ADDENDUM NUMBER 2

Re: North Brunswick High School HVAC
South Brunswick High School HVAC
West Brunswick High School HVAC
Brunswick County Schools
Proj. Number: PC21P0006

MDI Proj. No.: 213763

M103A

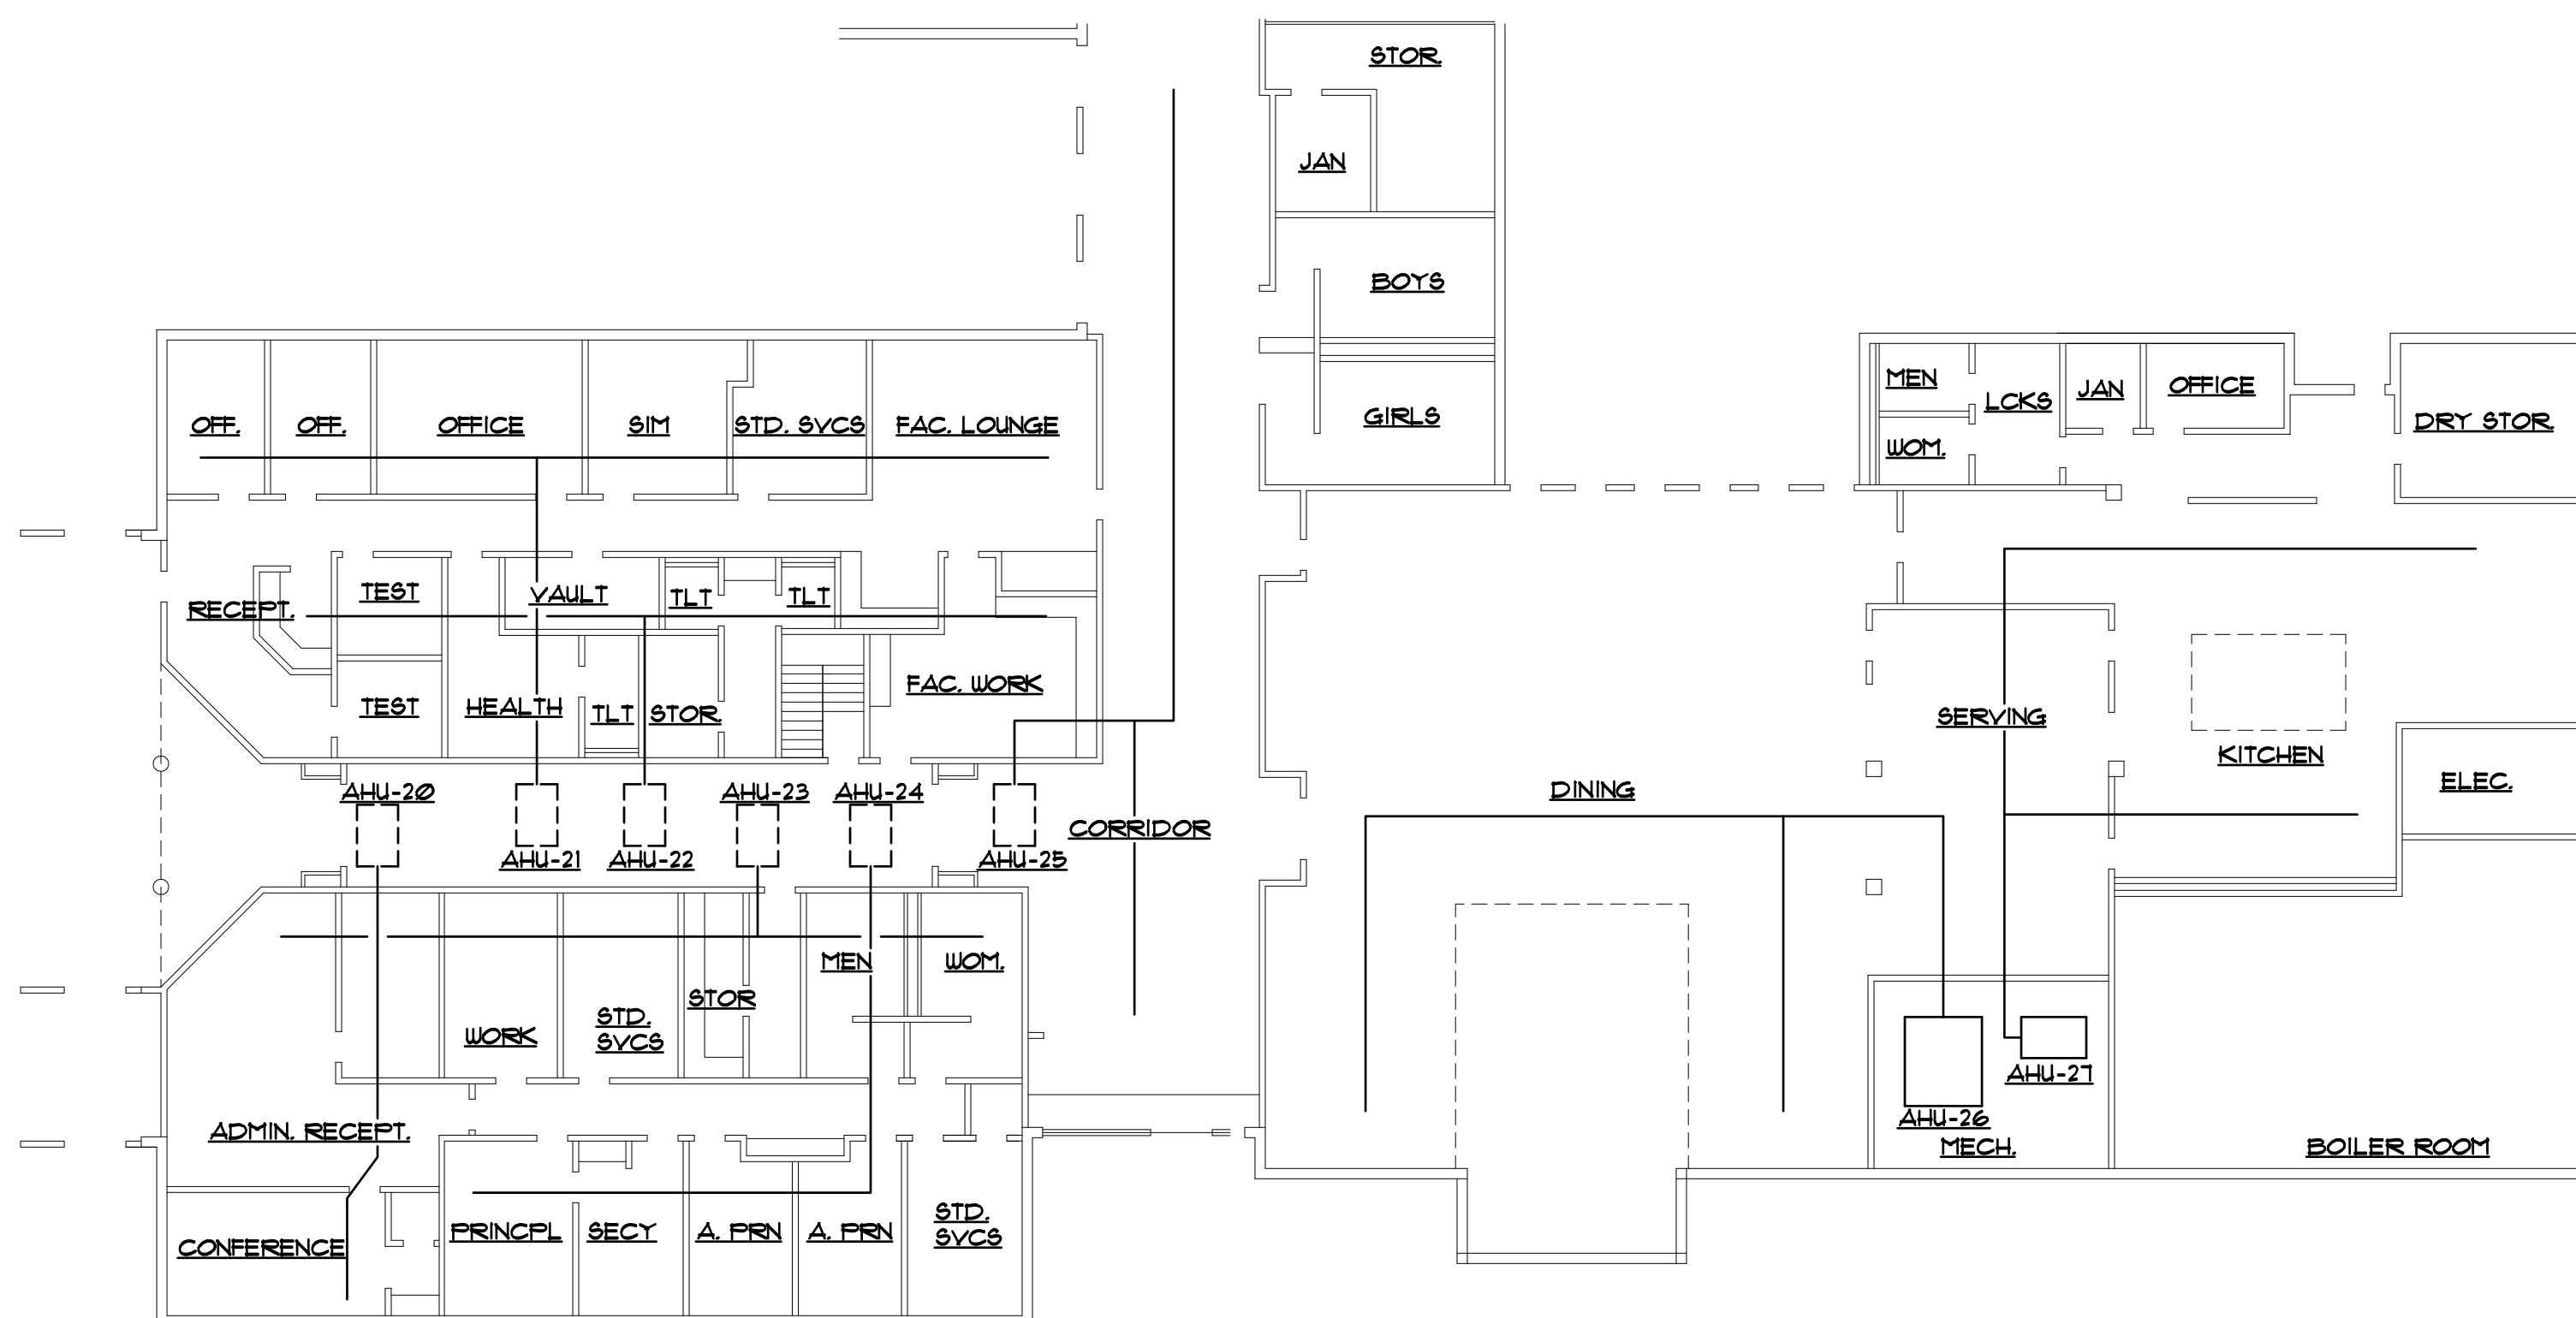
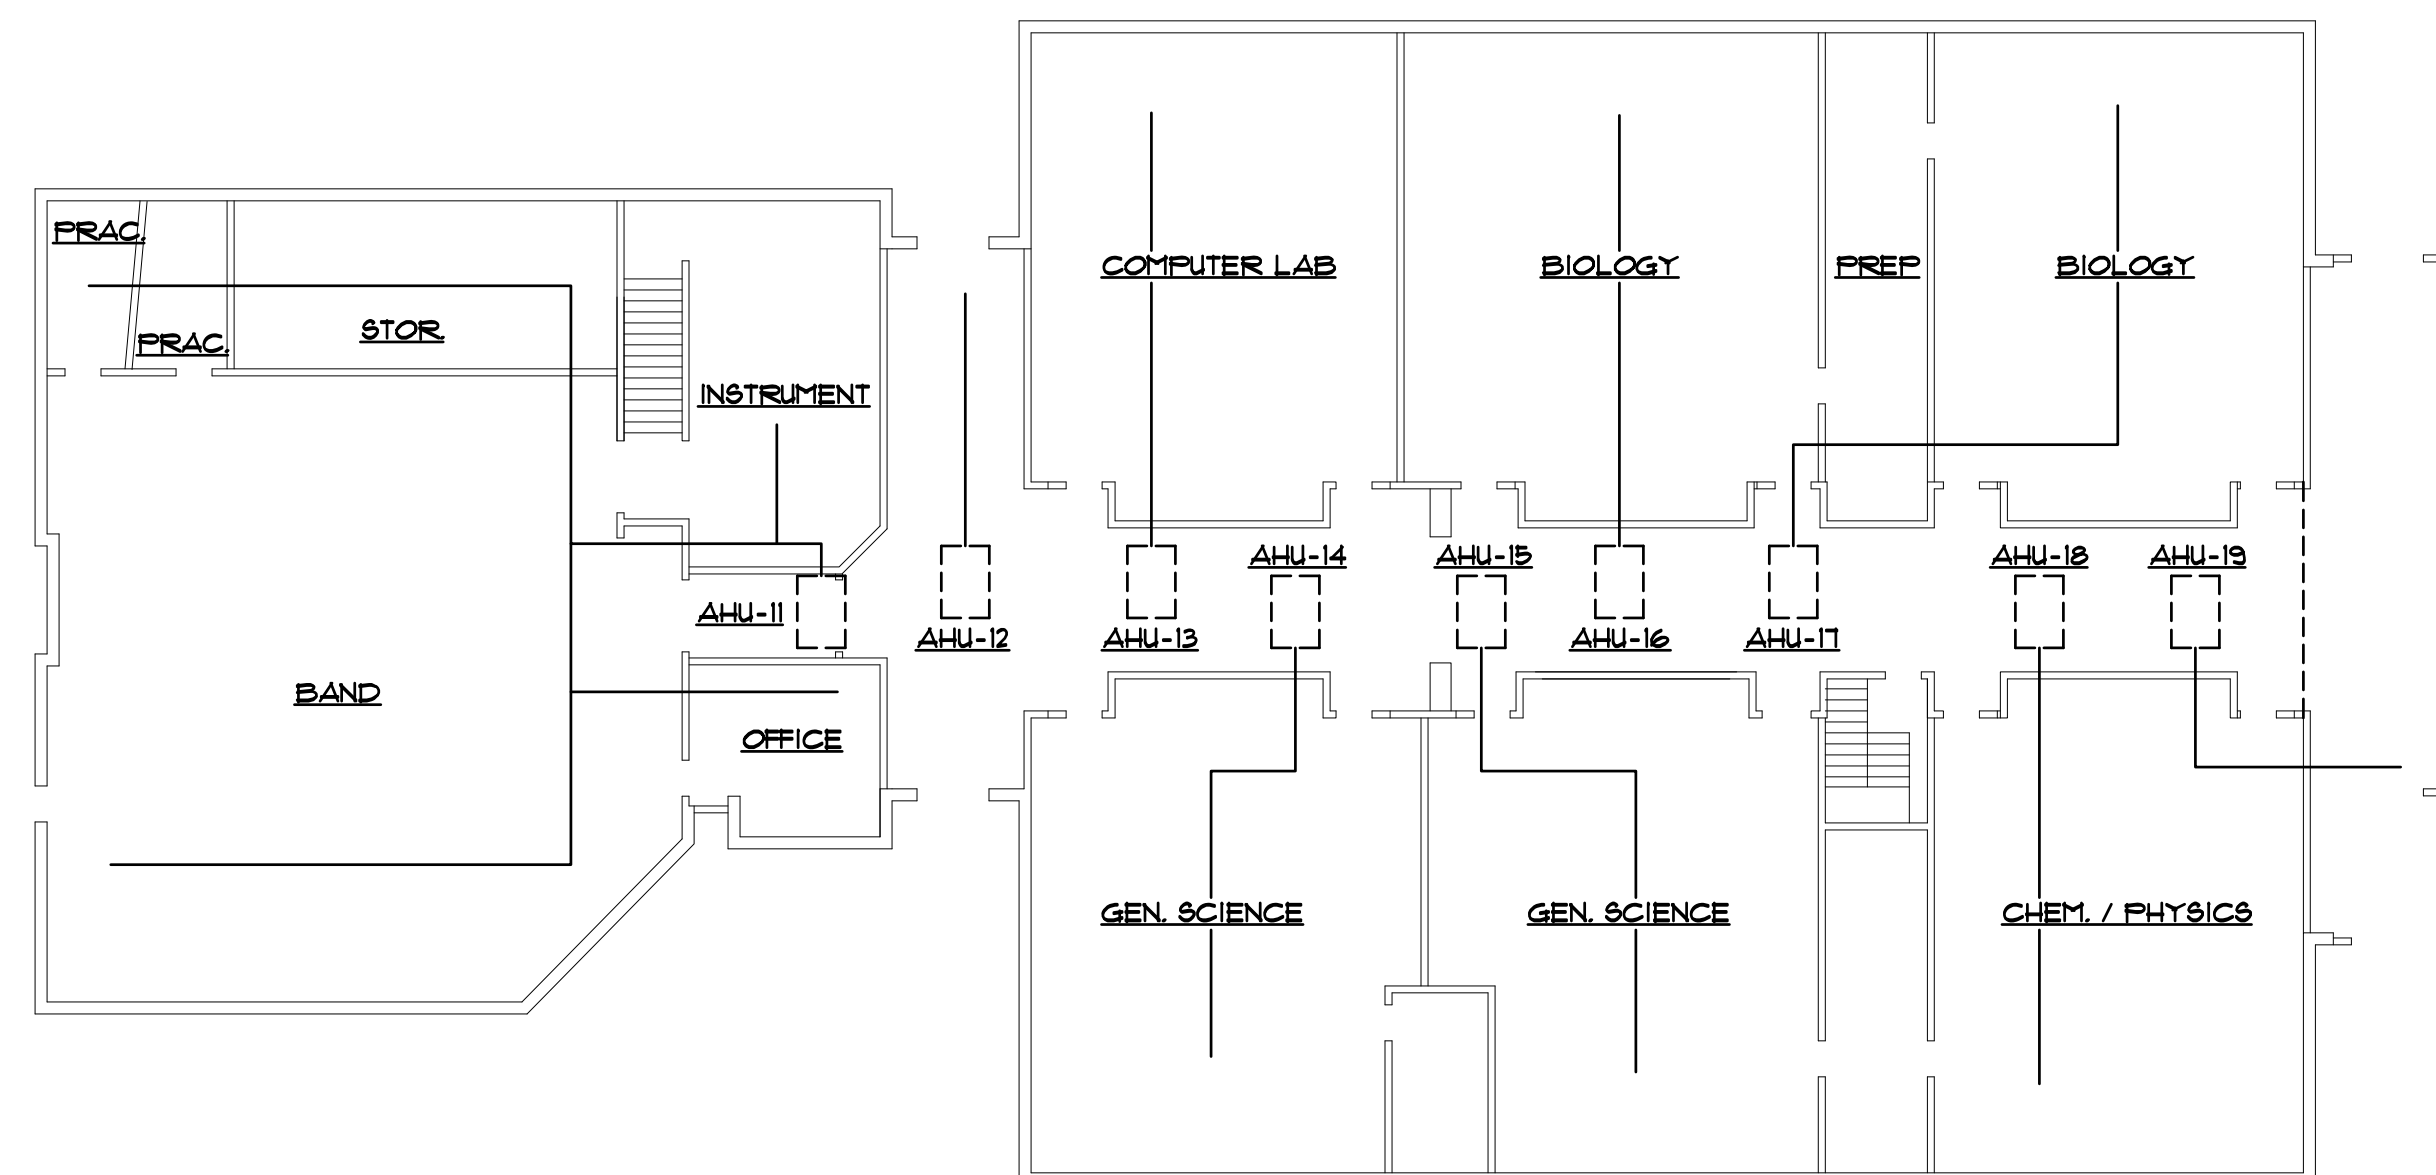
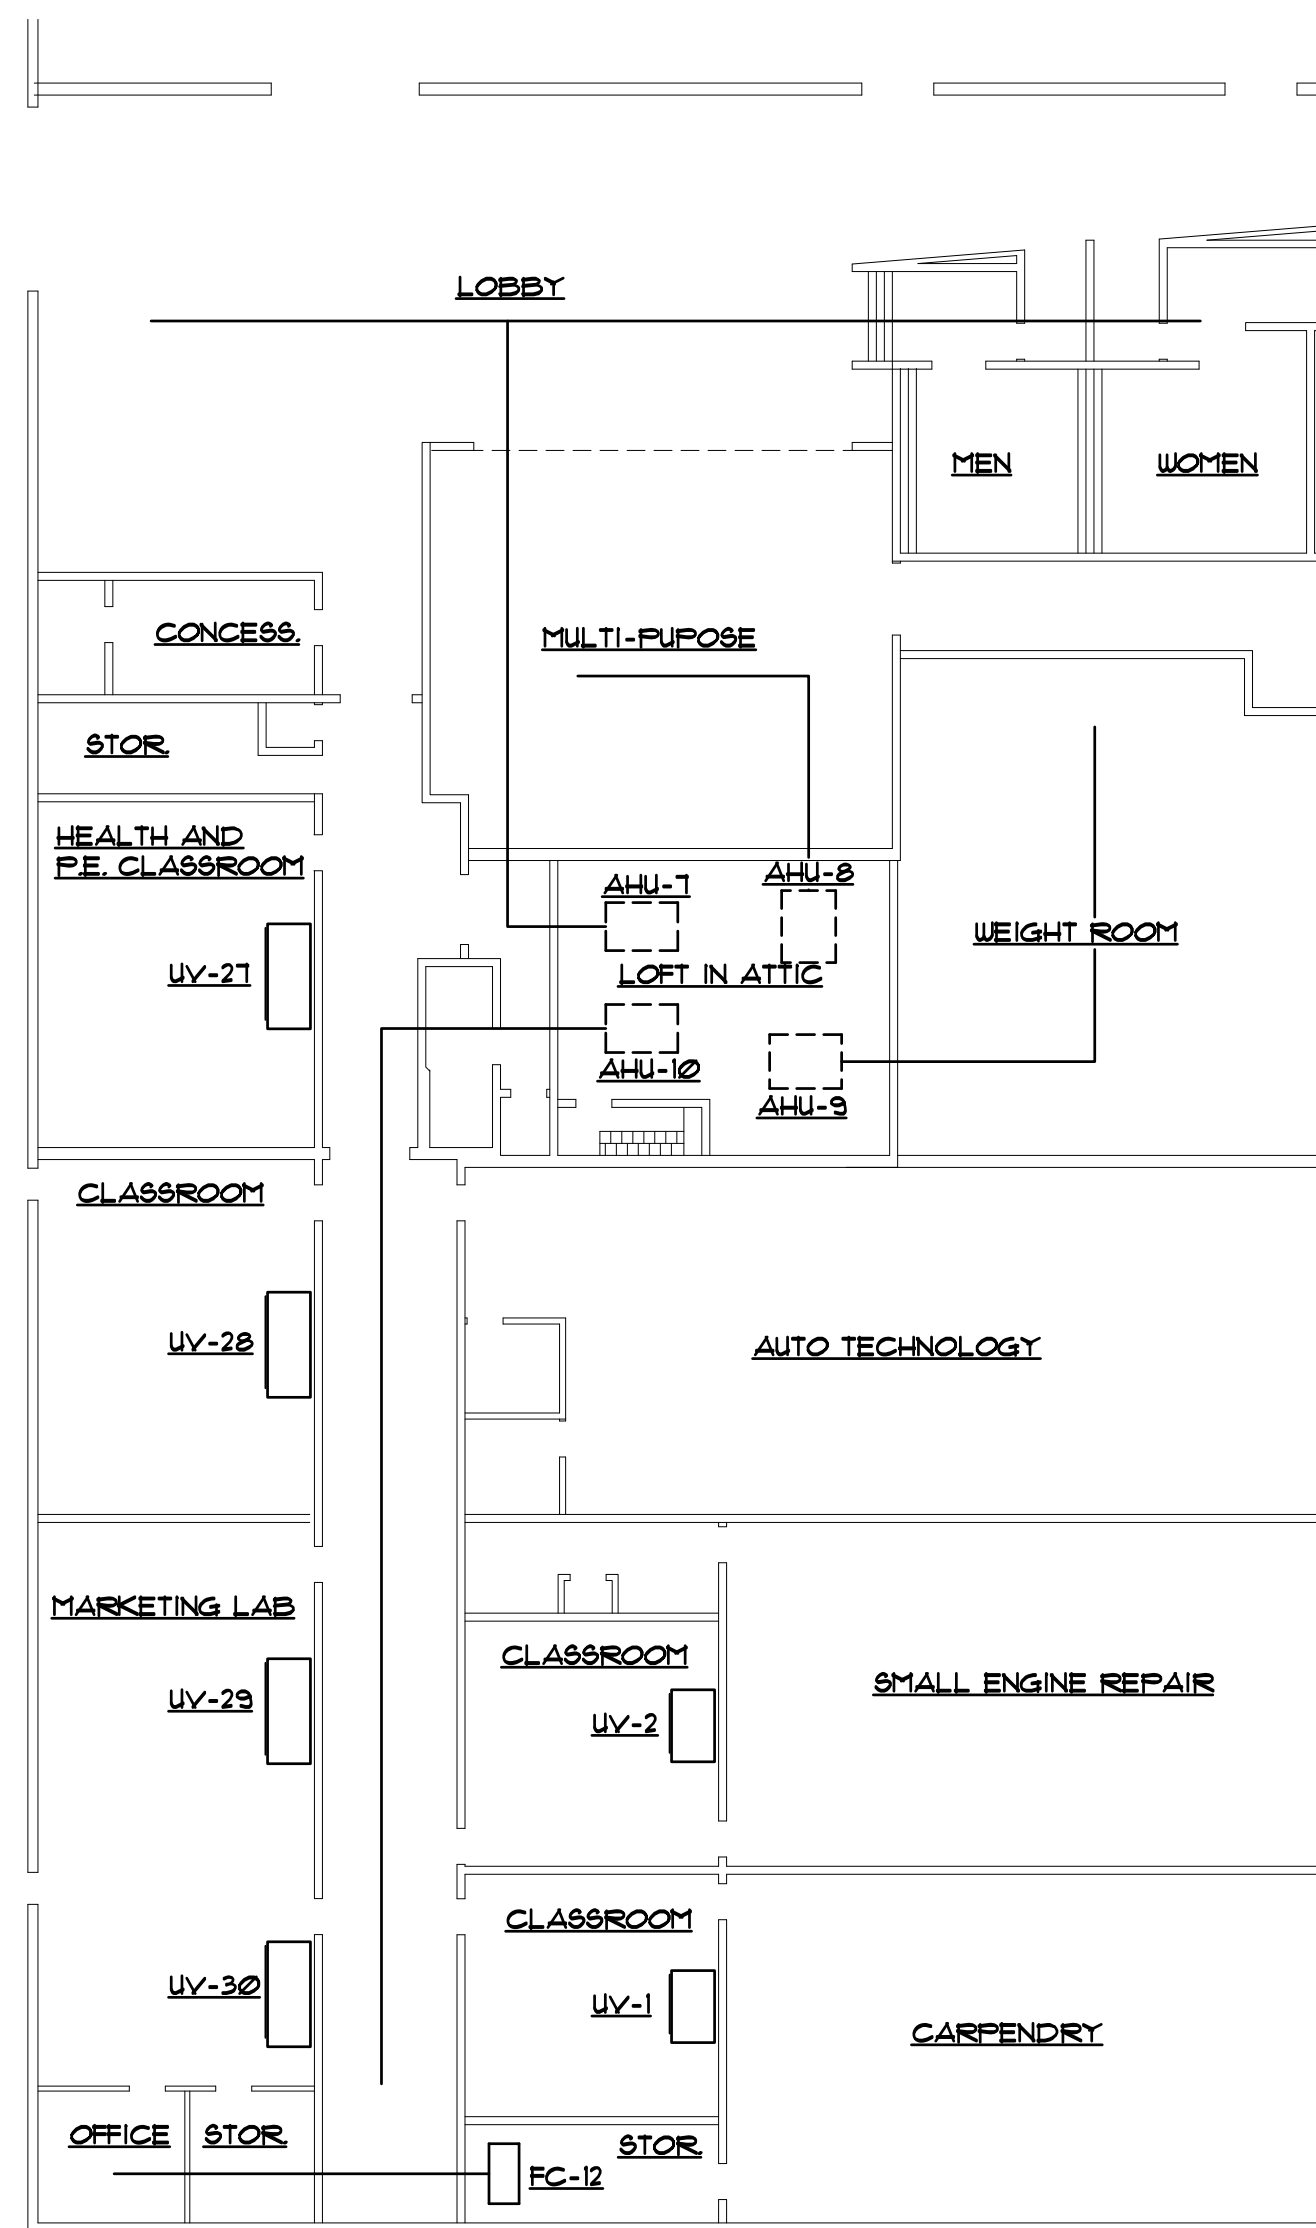
3. Refer to North Brunswick High School drawing M103A, areas "C", "D", "E", and "F". Remove existing control valves complete, and replace with new control valves furnished by automatic temperature controls company as noted on the Control Valve Replacement Schedule on M001A.
